MIAMI-DADE COUNTY

The Miami-Dade Water and Sewer Department and this Department's Code Coordination & Environmental Initiatives Division find the Application for Development Approval to be deficient and note that additional information is required:

Walkability - Commercial

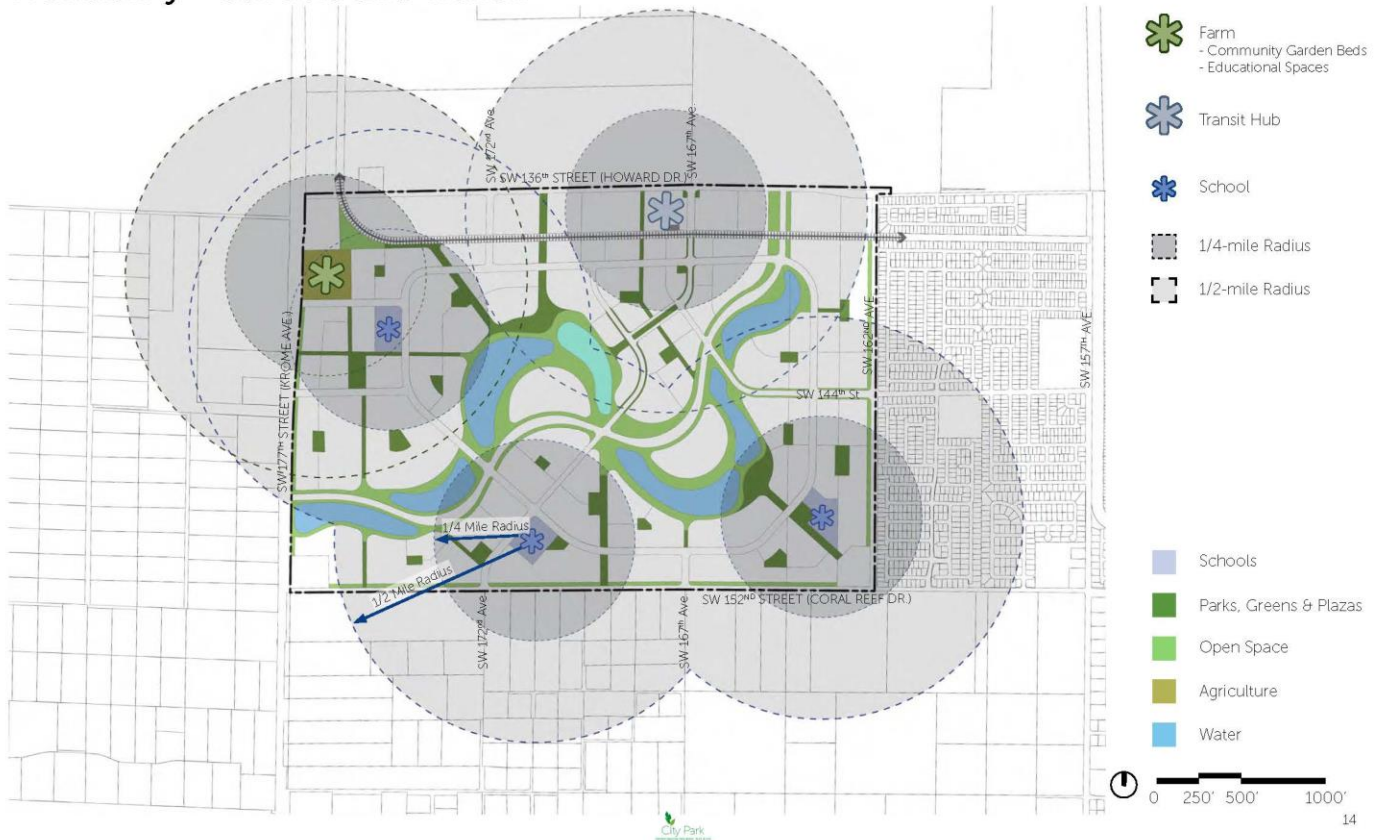
- 10. Page 10-4: Provide the maximum and average walking distance from the farthest residential units to their nearest commercial/infrastructure areas to serve resident daily-need land uses (e.g., grocery, pharmacy, school, transit stop). This information is essential to evaluate the walkability and functional integration of the proposed development. This information should be verified with a map showing the furthest distances of residential units to commercial/infrastructure areas to serve resident daily-need land uses (e.g., grocery, pharmacy, school, transit stop)**

Response: The two walkability graphics shown below illustrate how City Park is organized to place daily destinations within convenient walking distance of residential neighborhoods.

The **Walkability – Commercial** graphic illustrates the distribution of commercial areas throughout City Park, including commercial, TOD mixed-use, Village mixed-use, and Farm mixed-use locations. The graphic demonstrates that retail and service uses are planned at multiple locations across the site, including the Village Core, northern mixed-use areas, and selected gateway locations, so that commercial activity is accessible to surrounding neighborhoods rather than concentrated in a single retail node. The 1/4-mile and 1/2-mile radii also extend beyond the City Park boundary, demonstrating that residents in surrounding areas outside City Park will have convenient access to neighborhood-serving commercial uses intended to meet daily shopping, dining, and service needs. Based on the radii shown, **approximately 44% of the City Park site is within a 1/4-mile distance** of a commercial area, and **approximately 97% or more of the site is within a 1/2-mile distance** of a commercial area.

The **Walkability – Schools and Transit** graphic illustrates the planned relationship between schools, the transit hub, the farm, parks, open space, and water features. The graphic shows that schools and transit-supportive facilities are distributed to serve multiple neighborhoods and are connected through the project's open space and pedestrian framework. The 1/4-mile and 1/2-mile radii extend off site, indicating that these community-serving uses will also be conveniently accessible to nearby residents outside City Park. Based on the radii shown, **approximately half of the City Park site is within a 1/4-mile distance** of a school, transit hub, or farm/community education area, and **approximately 98% of the site is within a 1/2-mile distance** of one of these community-serving destinations.
